Review Comments

Project: Brighton Recovery Campus-Building D
Project No: 20160686

From: Jason Worthen
Date: April 12, 2017

BUILDING D RESPONSES

1 POWER PLAN - BUILDING 'D'
SCALE: 1/4"=1'-0"

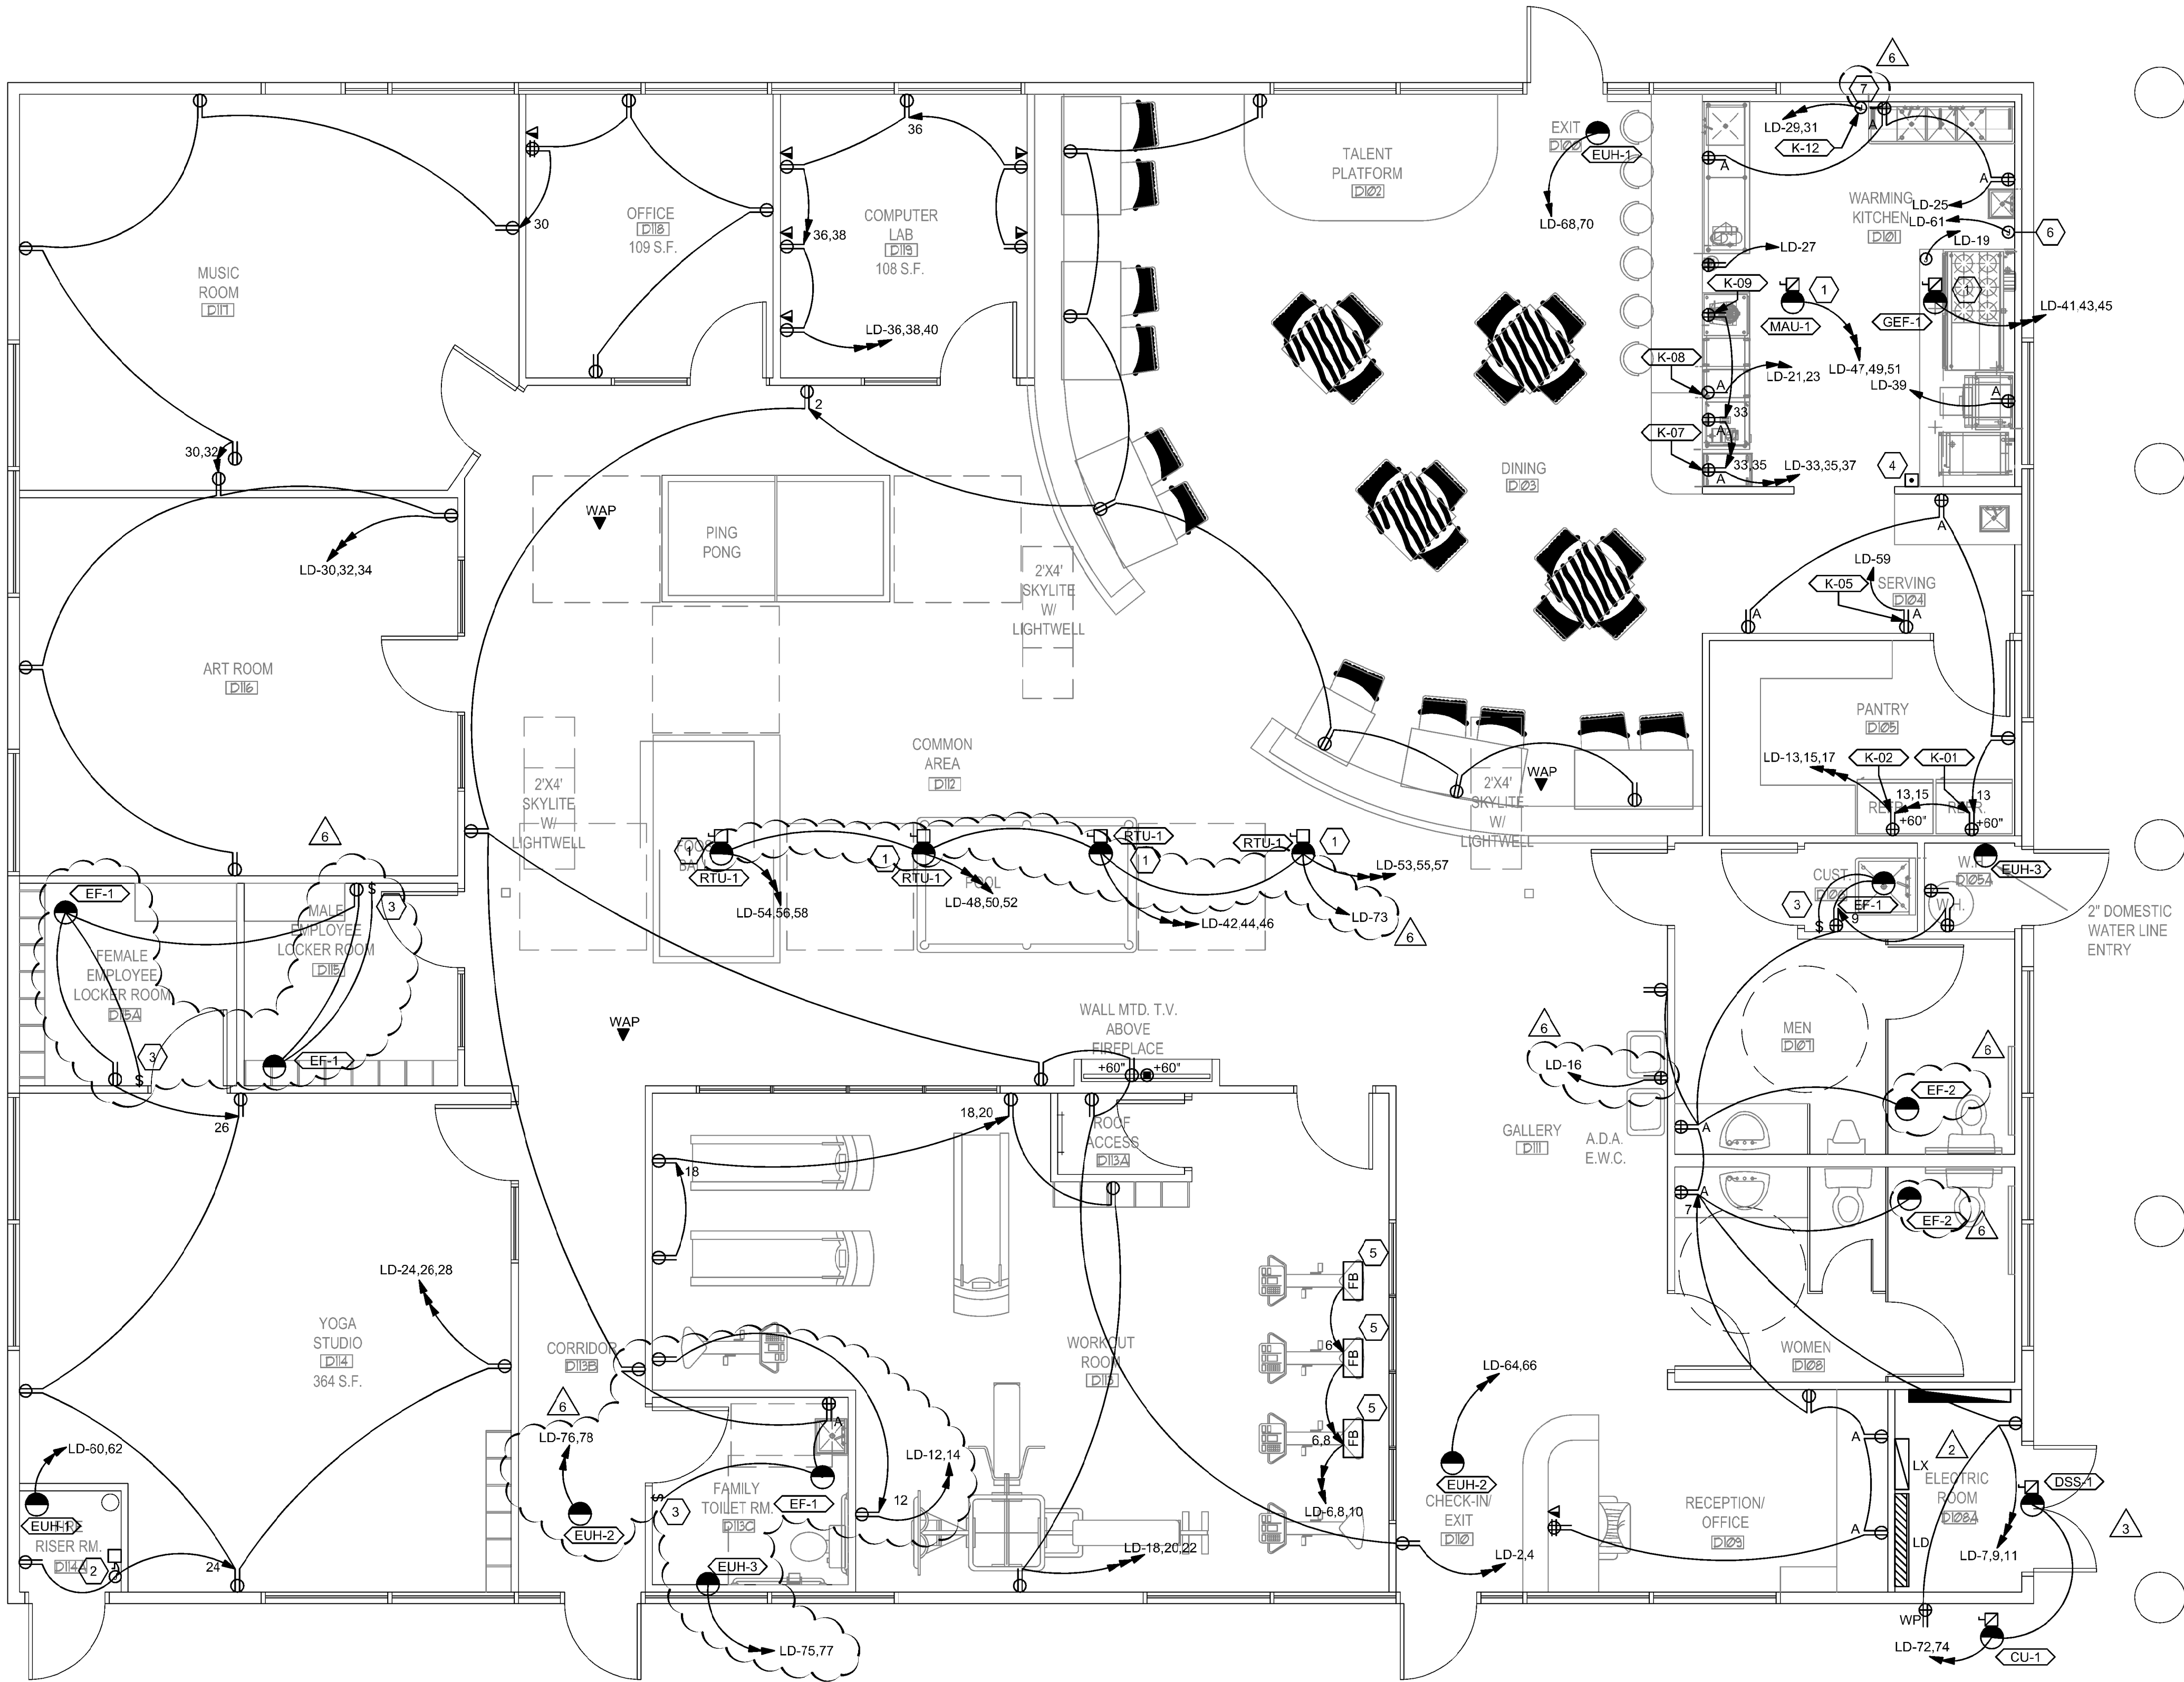
E1. Dishwasher shall be GFCI protected per NEC210.8 (D).

E3. Please note on electrical roof top plan WP GFCI for RTU units per NEC 210.63.

EP11D (see attached sheet)

1. Added keynote requiring the dishwasher be protected by a GFCI circuit breaker.
2. Added one 120V circuit for receptacles provided with roof top units and modified key note #1.
3. Added a duplex receptacle in the new corridor by the yoga studio.
4. Added power connection for EUH-2 in Corridor by the Yoga Studio.
5. Deleted one duplex receptacle in workout room. Relocated two duplex receptacles to accommodate Family Toilet
6. Added one above counter GFCI receptacle for Family Toilet.
7. Added a dedicated duplex receptacle for drinking fountains.
8. Changed exhaust fans in Men D107 and Women D108 from EF-1 fans to EF-2 fans.
9. Added power for exhaust fans in both employee locker rooms.
10. Added power for exhaust fan and unit heater in Family Toilet D113C.

Response: Added a note requiring GFCI circuit breaker in the panel for the circuit feeding the dishwasher.

Response: Provided 120 volt circuit to all rooftop units for GFI WP receptacle that will be provided with unit.

1. RTU LOCATED ON ROOF. PROVIDE 208/3 DEDICATD CIRCUIT FOR EACH RTU AND A 120/1 CIRCUIT FOR ALL CONVENIENCE OUTLETS INTEGRAL WITH RTU.
2. PROVIDE DEDICATED 120V CIRCUIT AND A 30/3P DISCONNECT FOR FIRE ENTRY FLOW SWITCH AND AIR COMPRESSOR.
3. PROVIDE A 20A/1P SWITCH TO CONTROL EXHAUST FAN.
4. EMERGENCY FIRE SHUTOFF SWITCH. SWITCH TO CLOSE GAS LINE SOLENOID VALVE.
5. PROVIDE LEGRAND EVOLUTION SERIES FLUSH MOUNT FLOOR BOX WITH TWO DUPLEX RECEPTACLES.
6. PROVIDE 120V POWER TO ANSUL FIRE SYSTEM PANEL. PROVIDE 120V POWER TO GAS LINE SOLENOID SHUTOFF VALVE.
7. PROVIDE A GFCI TYPE CIRCUIT BREAKER IN PANEL LD FOR DISHWASHER.

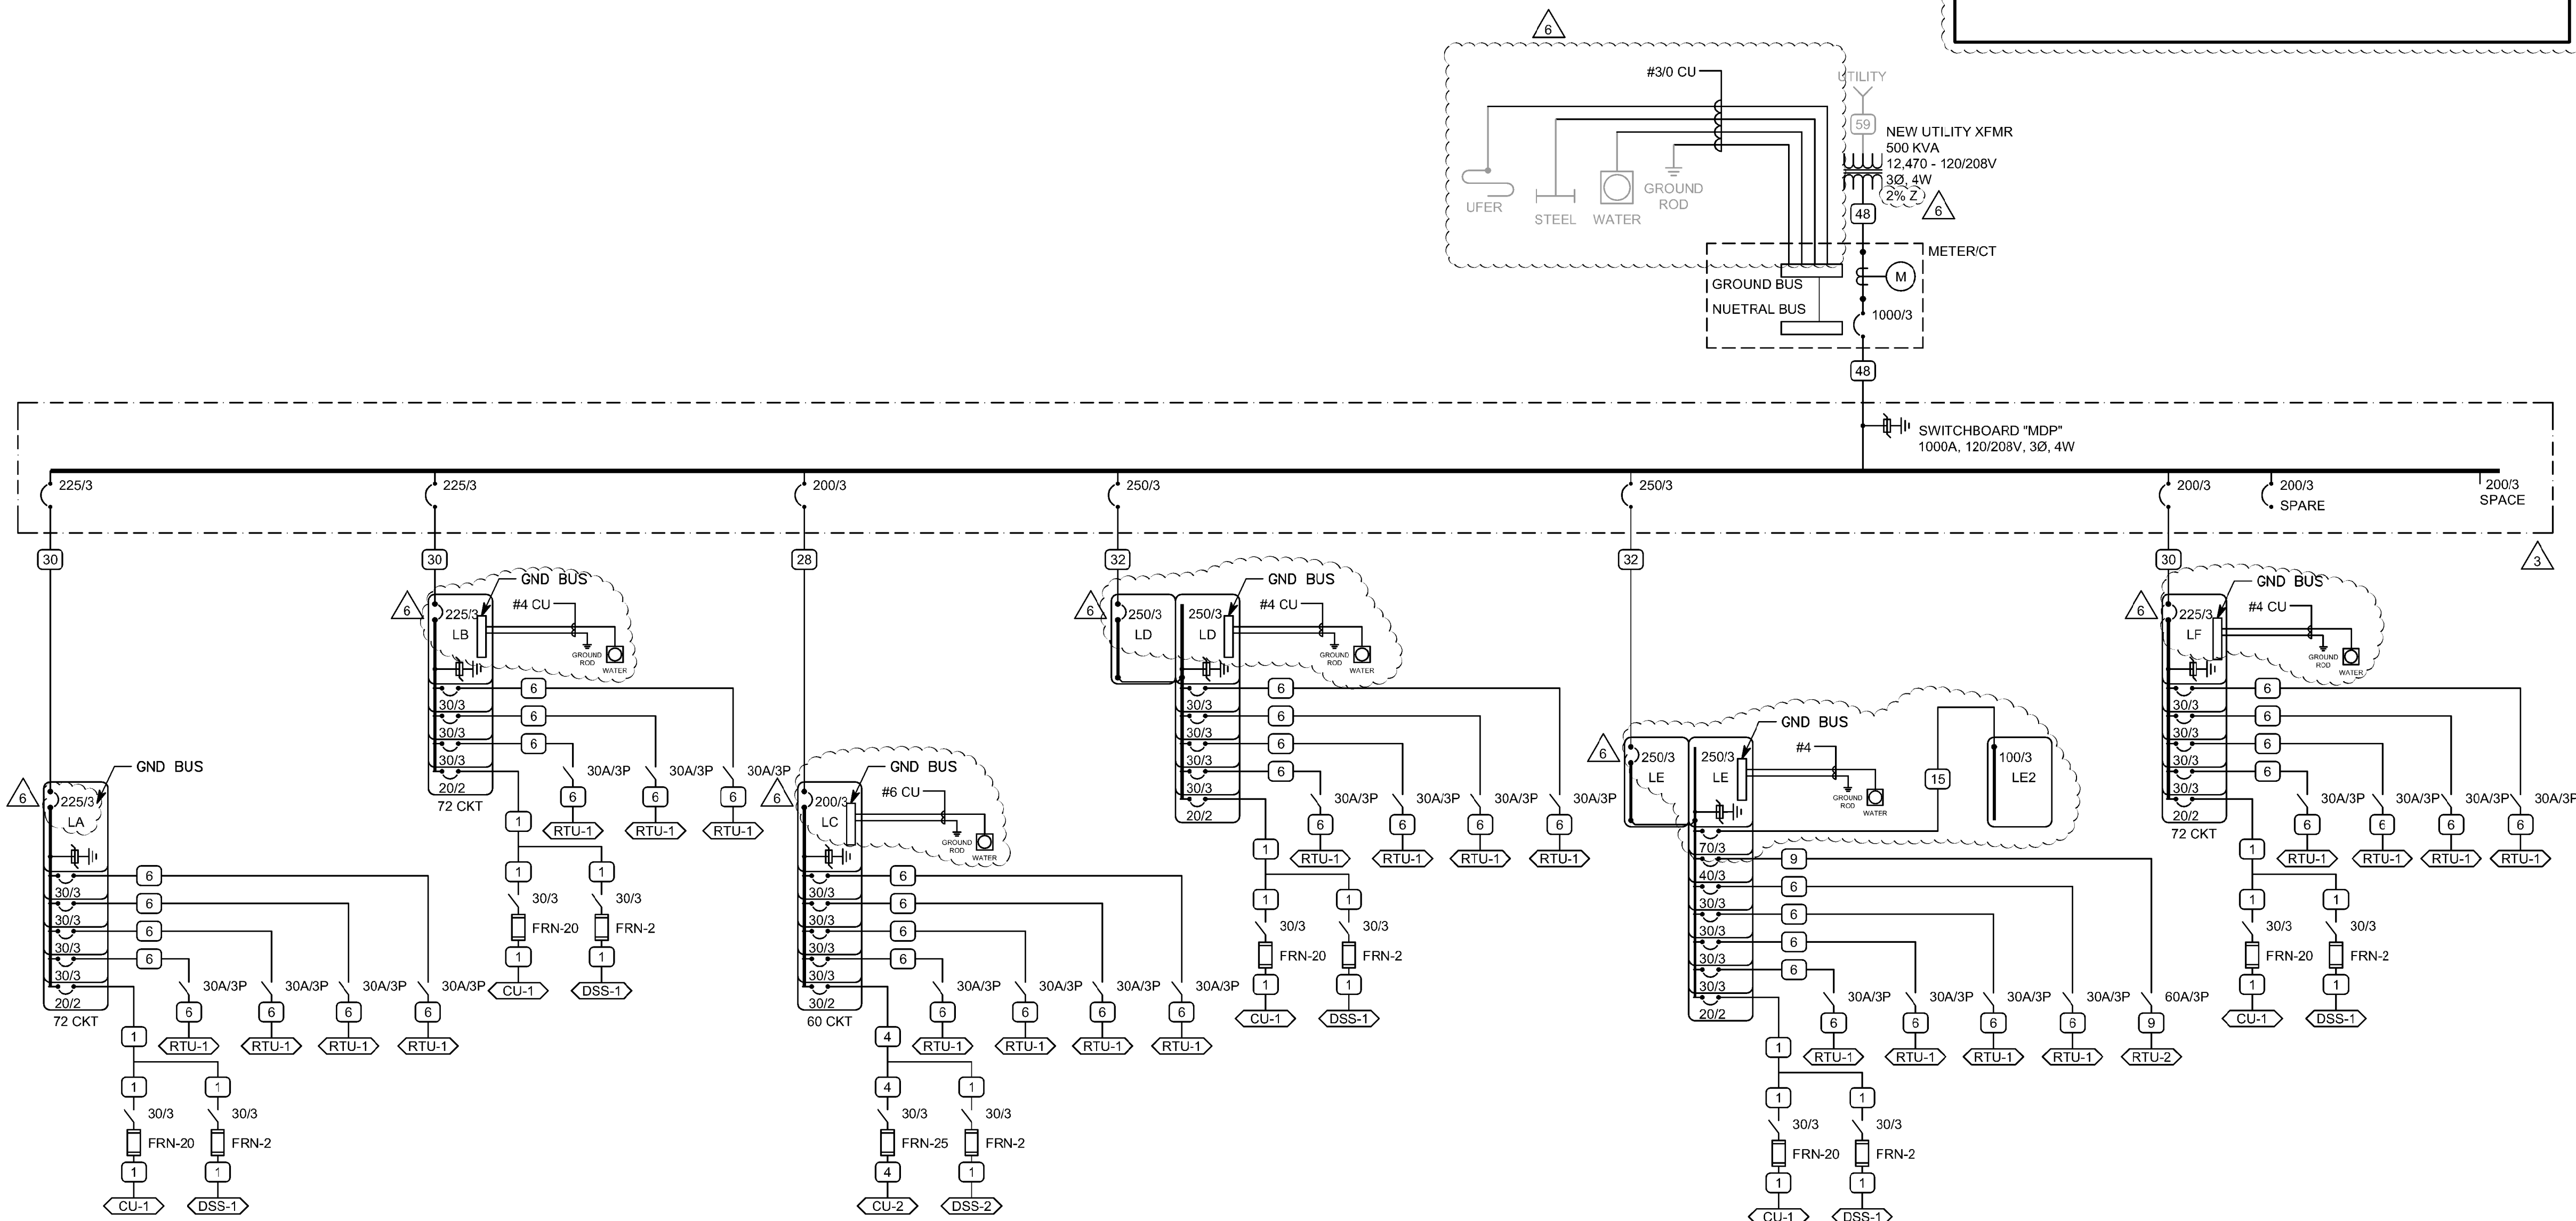
E2. Sheet E601: Please note and verify location of the concrete encased grounding electrode.

E4. Please provide complete and detailed available fault current calculations (in accordance with NEC 110.9 and 110.10) and show the following on the plans:

V. Specify on the plans the short circuit ratings of all overcurrent protection devices, or add a note on the plans that all overcurrent protective devices will have the same fault current rating as the rating of the panel or switchgear they are located within.

VI. Please indicate on the plans that the calculated available fault current that could be provided to each equipment will be field marked as required by NEC110.24(A).

EP601 (see attached sheet)

1. Added impedance for the transformer that was used for fault current calculations.
2. Added general note calling for all overcurrent protective devices to have the same AIC rating as the panel or gear they are located within.
3. Added a general note requiring that all electrical equipment be field marked with the calculated available fault current.
4. Changed one-line diagram to shown the grounding electrodes as existing.
5. Changed all branch circuit panels from main lugs only to main circuit breaker panels.
6. Added panel LE2.
7. Added EF-2 to the equipment schedule.
8. Added grounding electrodes and grounding electrode conductors for the panels in buildings B, C, D, E and F.

Response: Modified grounding electrode circuiting on one-line diagram (EP601) instructing the contractor to connect the new services ground bus to the building existing grounding electrode system.

Response: Added impedance of the utility transformer to one-line diagram. KVA rating is already shown.

Response: This information is shown in the fault current table on EP601.

Response: Added general note to EP601 calling for all overcurrent protective devices to have the same AIC rating as the panel or gear they are located within.

Response: Added a general note to EP601 requiring that all electrical equipment be field marked with the calculated available fault current.

- ALL OVERCURRENT PROTECTIVE DEVICES SHALL HAVE THE SAME AIC RATING AS THE PANEL OR GEAR THEY ARE LOCATED WITHIN.
- ALL ELECTRICAL EQUIPMENT SHALL BE FIELD MARKED WITH THE CALCULATED AVAILABLE FAULT CURRENT PER NEC 110.24(A).
